~~Base document for ALKS for low speed application prepared by co-chairs~~

~~Unchanged text (compared to ACSF-23-02r3) in black — just without all the colours.~~

Proposal for Technical Requirements for an Automated Lane Keeping System

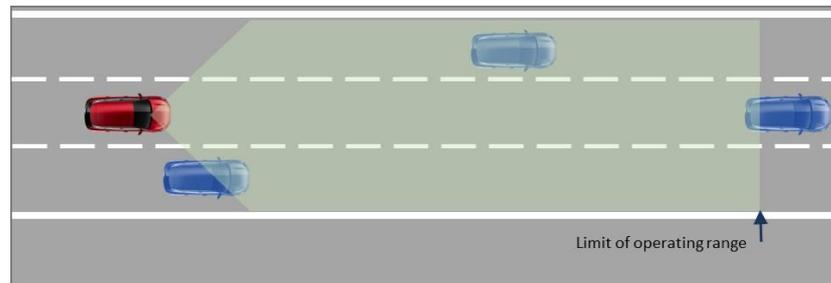
Comment to the table above: The table is derived from the Korean proposal in document 22.09 The values are rounded to ease the understanding and are capped at

~~2.0 seconds to align with the original proposal from Germany and OICA. For low speed systems the table could end at the corresponding max. operational speed.~~
